Superfund Record of Decision:

Picatinny Arsenal, NJ

RECORD OF DECISION
FOR
INTERIM GROUNDWATER REMEDIATION PLAN
PICATINNY ARSENAL, NEW JERSEY

RESPONSE TO EPA REGION II COMMENTS ON DRAFT RECORD OF DECISION (ROD)

FIGURE 3-1. FLOW SHEET FOR GROUNDWATER TREATMENT SYSTEM

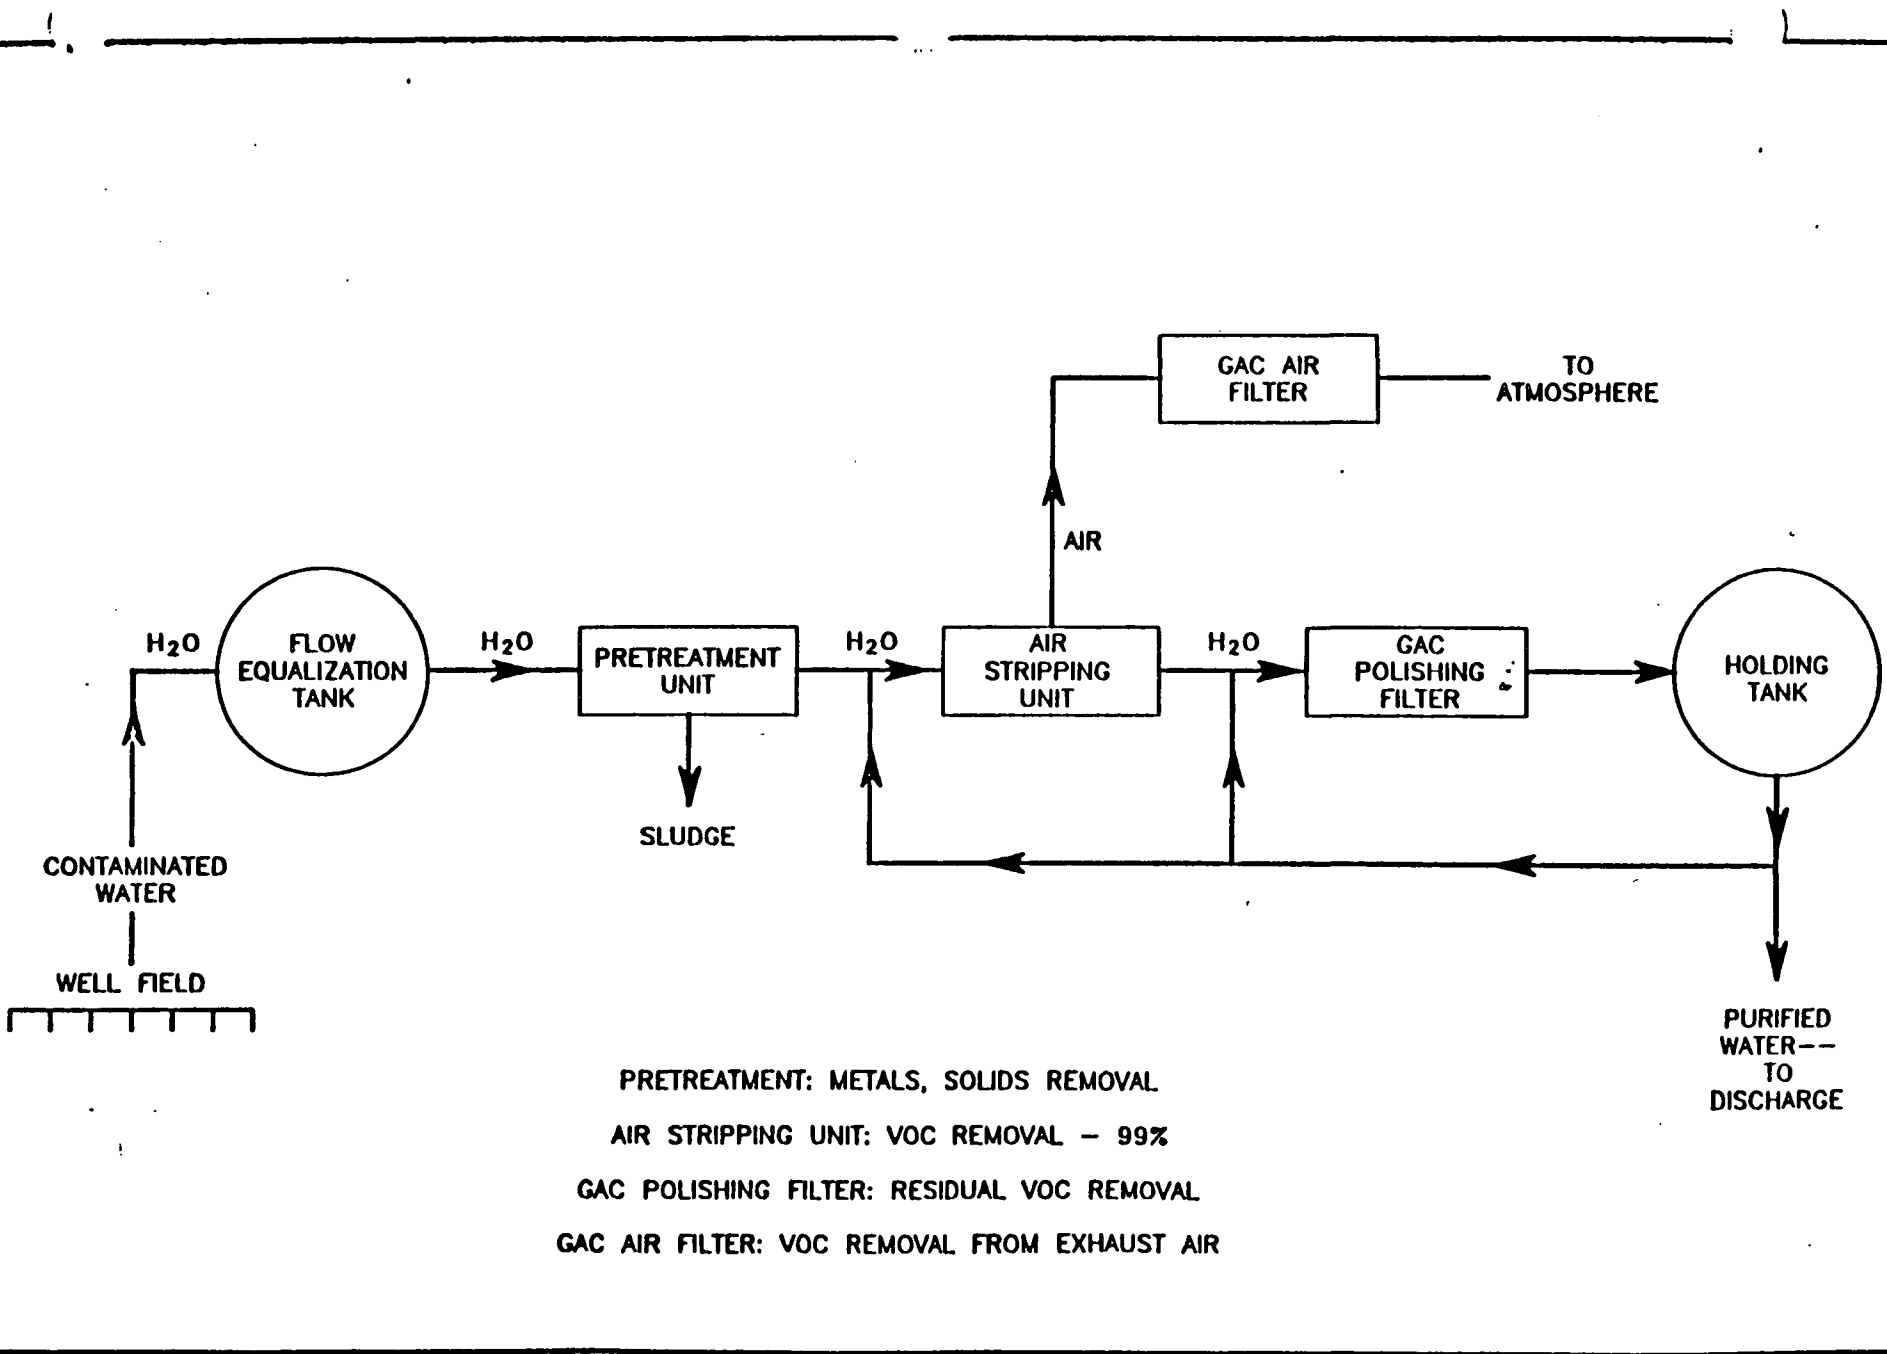
- a) Maps should be included in the ROD to show site locations, sampling locations, plume location, source area, etc..
- b) A flow diagram of the treatment train used in the proposed alternative 3C would be helpful. Arrows showing discharge should also show compliance with surface water or air emission ARARs.

b) Flow diagram added.
